# Memorandum to the City of Markham Committee of Adjustment

**File:** A/043/21  
**Address:** 40 Timbers Circle, Markham  
**Applicant:** Vipul & Madhavi Upadhyay  
**Agent:** Jay Upadhyay  
**Hearing Date:** Wednesday July 6, 2022

The Applicant is requesting permission to legalize a secondary suite in the basement of the existing townhouse dwelling (see Appendix “B” – Plans). The secondary suite has direct and separate access provided by an existing door on the west side of the dwelling, which is setback approximately 0.61 m (2.0 ft) from the interior side lot line. The door opens internally to the building.

DRAWING TITLE:  
**SITE PLAN**

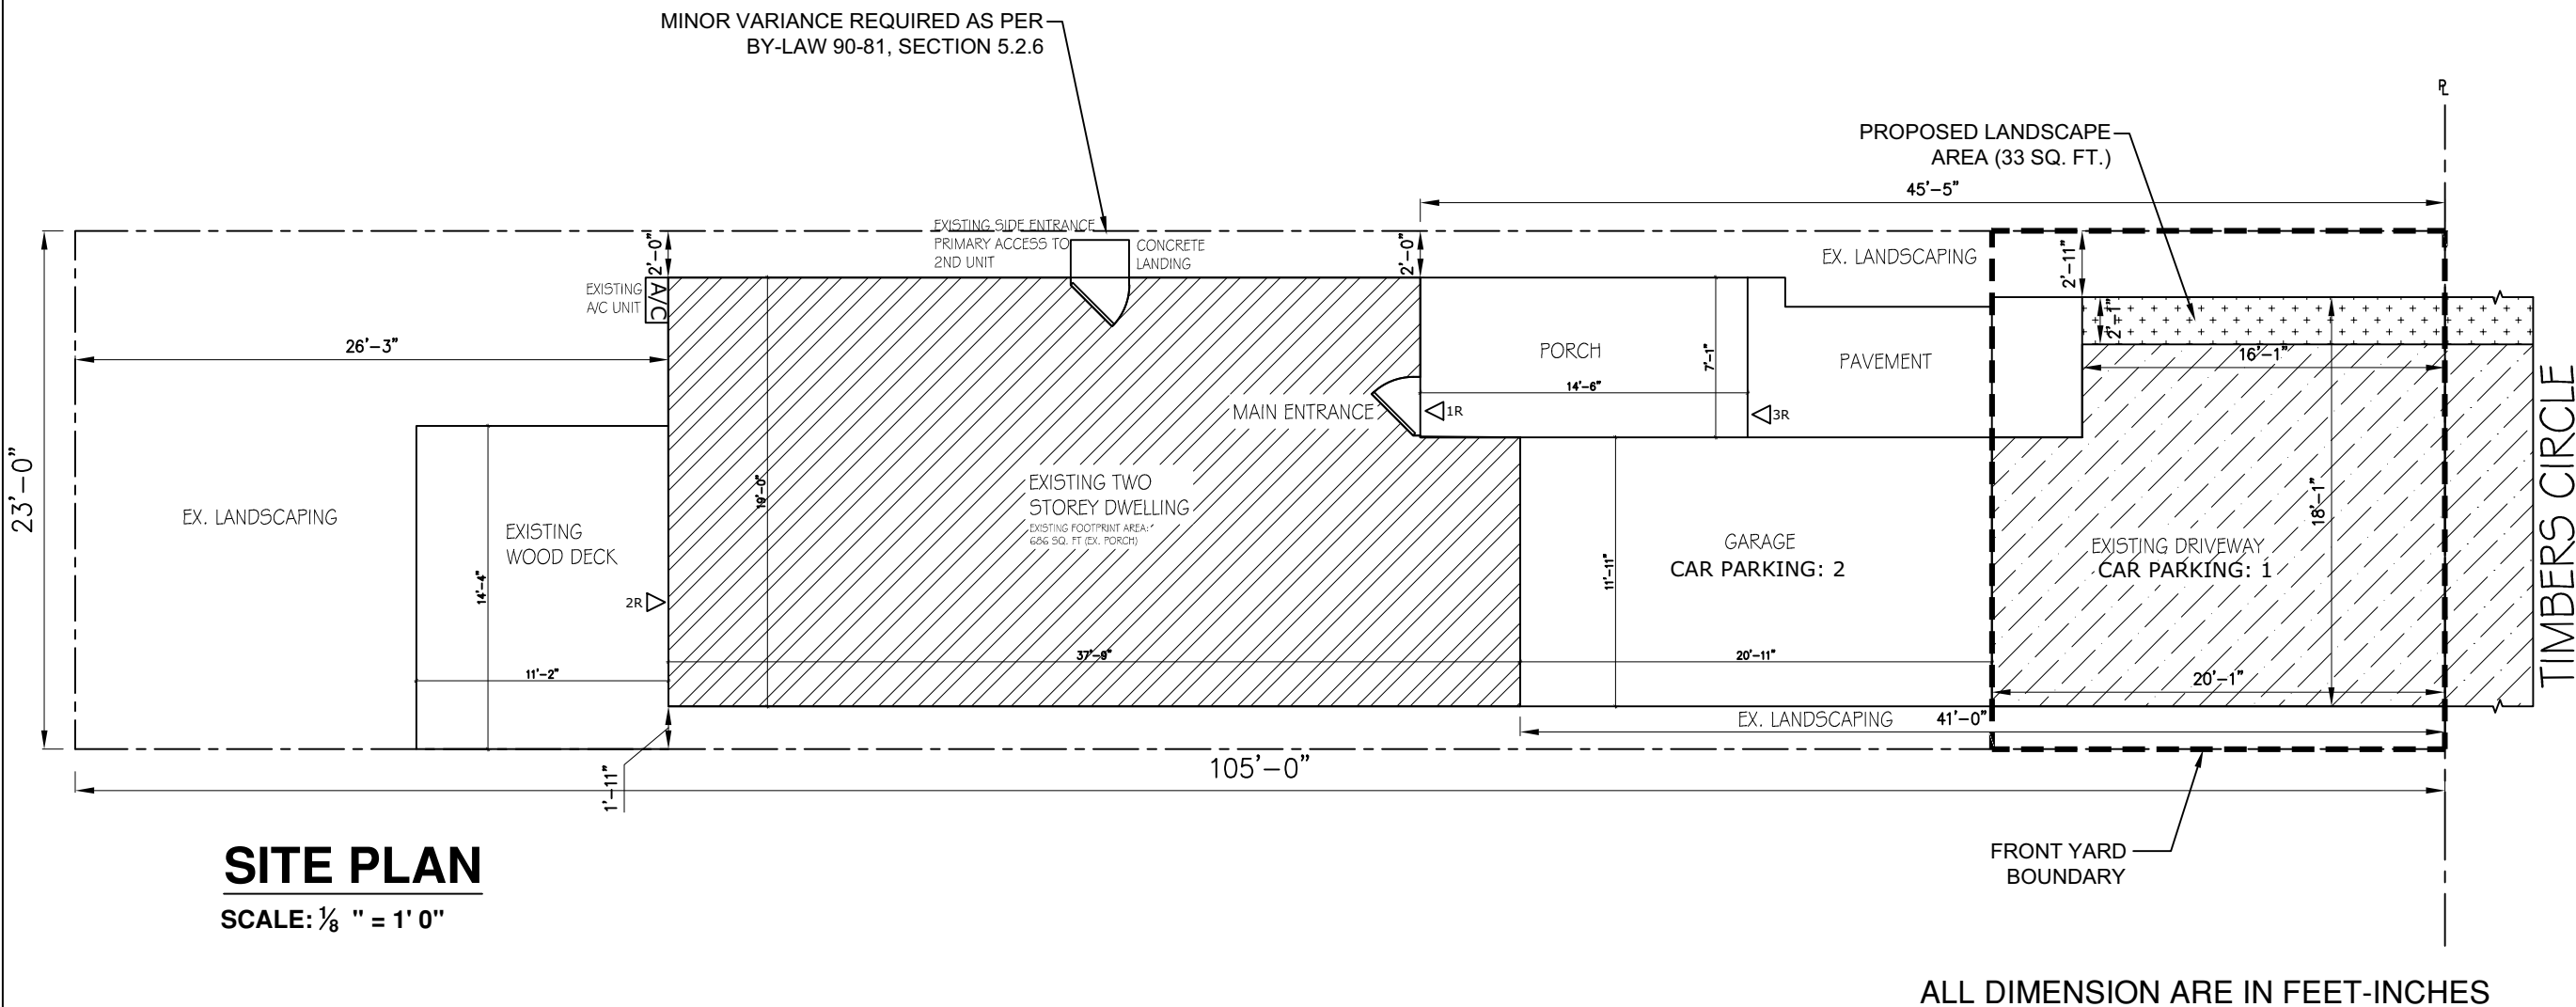
The Applicant is requesting an interior side door setback of 0.61 m (2.0 ft) from the interior easterly side lot line, whereas the By-law requires a minimum setback of 1.20 m (3.94 ft) to accommodate an existing side door entrance. This represents a reduction of 0.59 m (1.94 ft) or 49% from the By-law requirement.

Side yard setbacks of 0.61 m (2.0 ft) and 0.58 m (1.92 ft) are provided on the east side and west sides of the dwelling respectively. Staff are of the opinion that the existing side yard setbacks are already minimal, and will be further encumbered by a side door. Notwithstanding that the existing door swings internal to the dwelling, Staff are of the opinion that the requested variance does not meet the general intent of the By-law as the existing 0.61 m (2.0 ft) setback does not provide for an adequate width to access the side entrance.

Staff have received comments from the Engineering Department who have expressed concerns related to the location of the side door and associated concrete landing, as it does not permit enough room for a drainage swale.

Staff further note that the Fire Services department have also provided comments indicating that the setback to the side door will potentially hinder and obstruct accessibility of emergency personnel. An adequate secondary means of egress to and from the accessory dwelling is required.

Staff reached out to the Applicant to recommend that the secondary access be relocated to the rear (north side) of the dwelling. However, as the condition is existing, the Applicant intends to maintain the existing side door and to allow future tenants to use the main entrance as the primary means of accessing the secondary dwelling unit.

Staff are of the opinion that the requested variance to permit a 0.61 m (2.0 ft) setback for the side entrance does not maintain the intent of the By-law. Should the side entrance variance be denied, the Applicant will be required to provide access to the secondary suite elsewhere on the subject property and in compliance with the By-law and all other applicable codes.

1. The variances apply only to the proposed development as long as it remains.
2. That an outwards swinging door located along the east side of the dwelling not be permitted.
